UNITED STATES PATENT AND TRADEMARK OFFICE

APPLICATION NO.	FILING DATE	FIRST NAMED INVENTOR	ATTORNEY DOCKET NO.	CONFIRMATION NO.
09/537,274	03/29/2000	Larry Eugene Mosley	884.240US1	7167

Office Action Summary

- 1) ☒ Responsive to communication(s) filed on 21 January 2003.
- 2a) ☒ This action is **FINAL**. 2b) ☐ This action is non-final.
- 3) ☐ Since this application is in condition for allowance except for formal matters, prosecution as to the merits is closed in accordance with the practice under *Ex parte Quayle*, 1935 C.D. 11, 453 O.G. 213.

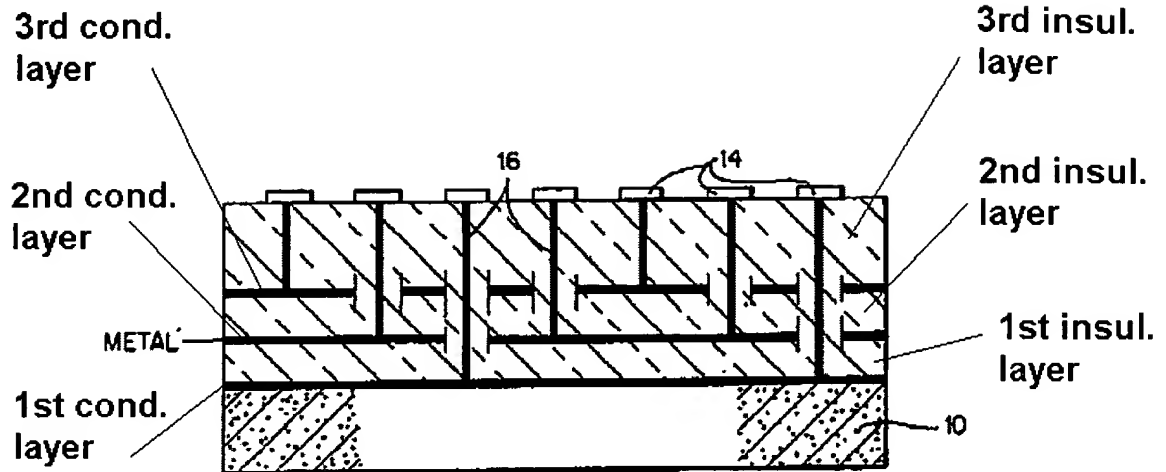
2. Claim 21 is rejected under 35 U.S.C. 112, second paragraph, as being indefinite for failing to particularly point out and distinctly claim the subject matter which applicant regards as the invention.

Claim 21 depends on a cancelled claim. The examiner examined this claim as if it depended on claim 2.

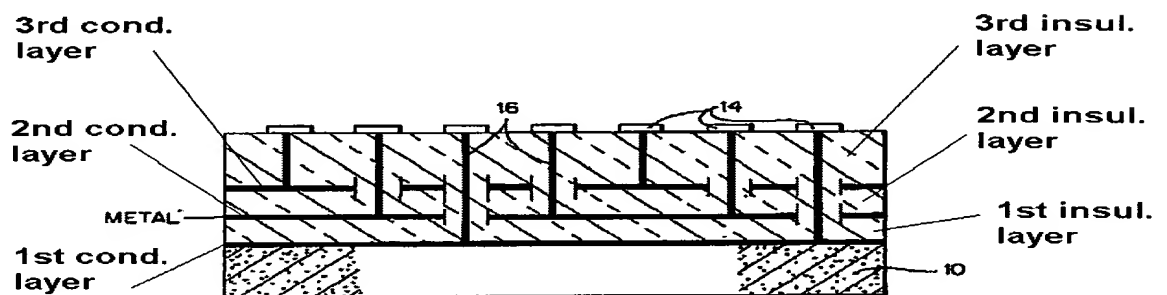
'3117 discloses the claimed invention except for the insulator layers are formed from a BaSrTiO₃ material. It is well known in the capacitor art to form insulating layers from a BaSrTiO₃ material (excellent dielectric properties). It

would have been obvious to one having ordinary skill in the art at the time the invention was made to form the dielectric from a BaSrTiO₃, since it has been held to be within the general skill of a worker in the art to select a known material on the basis of its suitability for the intended use as a matter of obvious design choice. In re Leshin, 125 USPQ 416.

Regarding claim 5, '3117 discloses the claimed invention for the conductive layers are formed from copper. It is well known in the capacitor art to form conductive layers (electrodes) from a copper material (excellent conductive properties). It would have been obvious to one having ordinary skill in the art at the time the invention was made to form the conductive layers from a copper material, since it has been held to be within the general skill of a worker in the art to select a known material on the basis of its suitability for the intended use as a matter of obvious design choice. In re Leshin, 125 USPQ 416.

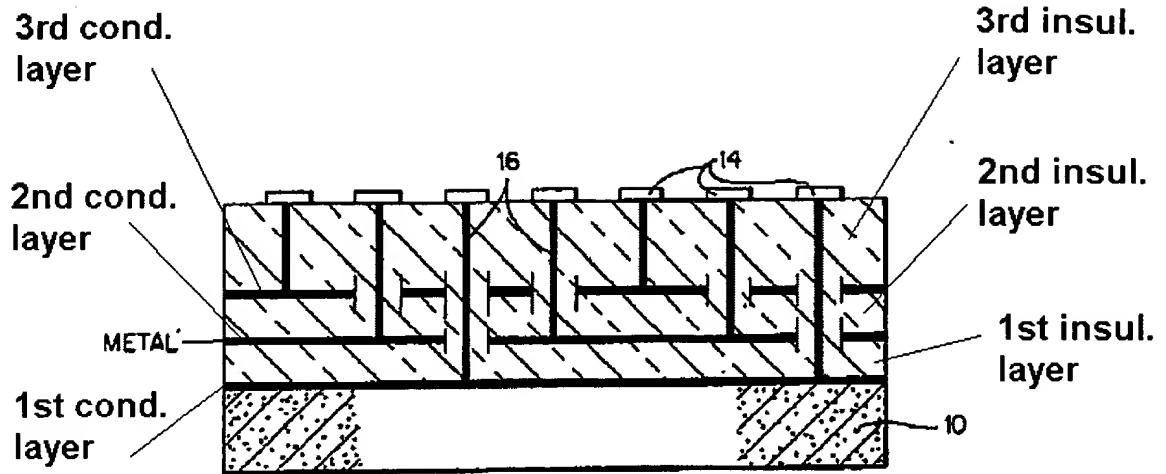
'3117 discloses the claimed invention except for the plurality of vias extending through the substrate to provide electrical interconnection to both a top surface and a bottom surface of the integrated circuit capacitor. It is well known in the capacitor art to extend vias through a substrate to provide electrical interconnections to both sides of the capacitive element. It would have been obvious to a person of ordinary skill in the art at the time the invention was made to extend the vias of '3117 through the substrate to provide electrical interconnections to both sides of the capacitor, since such a modification would decrease the space needed in the electrical system.
